# **KD9203 Firmware**

## **V2.2.37\_220316 Release Note**

Device Model	DS-KD9203-E6、 DS-KD9203-FE6、 DS-KD9203-TE6、 DS-KD9203-FTE6
Firmware Version	V2.2.37_220316
iVMS-4200 Version	Late version
Hik-Connect APP	Late version

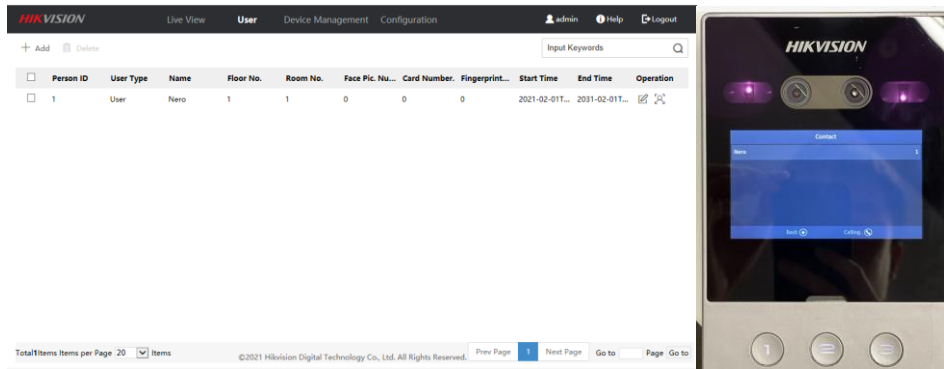
- 1、 HiK-Connect is disabled and Verification code is empty by default.
